Montgomery County Government

SUBJECT: Historic Area Work Permit Application

CASE NUMBER: 31/6 - 89W

PROPERTY ADDRESS: 3915 Baltimore St.

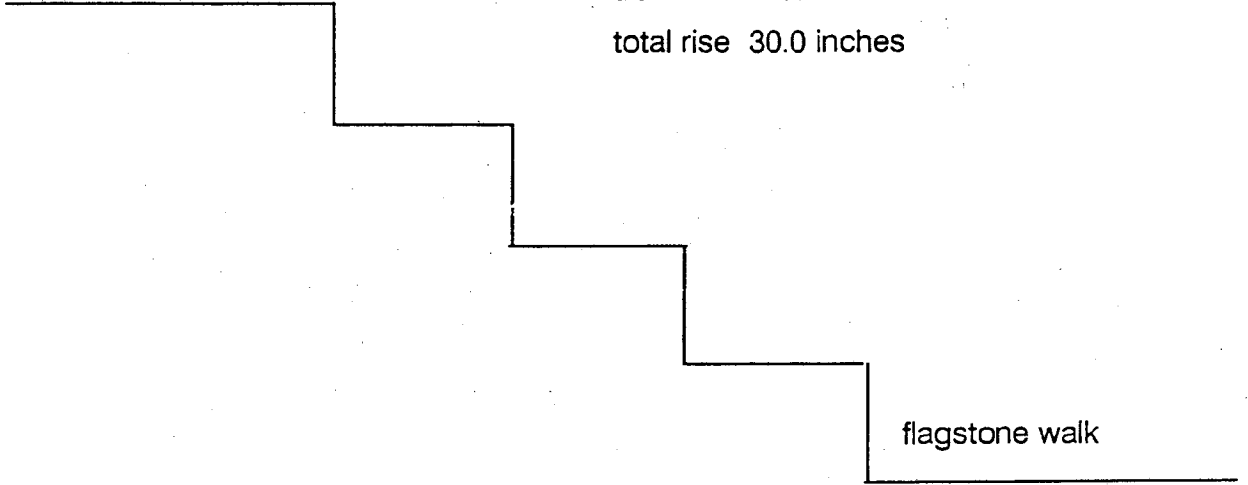
- Replacement of the concrete steps on the side of the house with a 3'-0" wide wooden stair per landscape master plan is a good move towards enhancing the primary historical resource - recommend approval.
- The pipe railing handrail, while unobtrusive, is a curious choice of material. Typically, wooden steps have wooden handrails, and concrete steps have steel pipe handrails. The choice of the metal handrail was not explained - so I'll ask at the review session, and I'll probably recommend a wooden rail.
- Will the eight-foot wide front stairs also be constructed of wood material? If so, I will recommend approval.
- Will the eight-foot wide front steps have any handrails? what material?
- The choice of flagstone paving material is excellent and juding from the the landscape plan, well thought out and designed. Recommend approval.

- Pipe railing approved 1988/89
in Kensington -

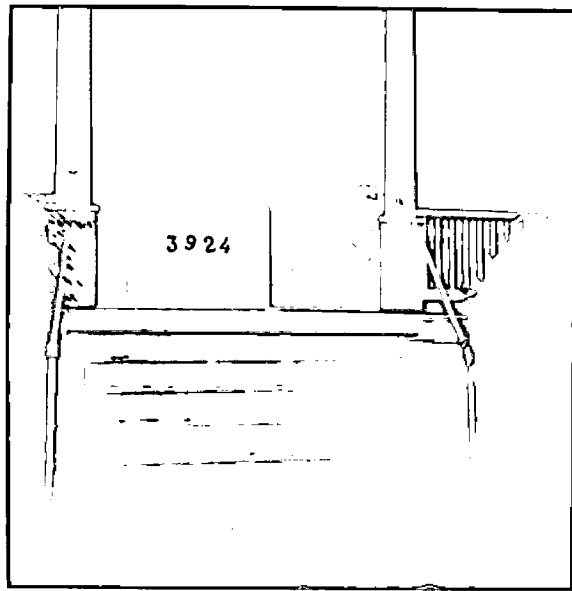
-Piperailing @ 3924 Baltimore-
we will use this type
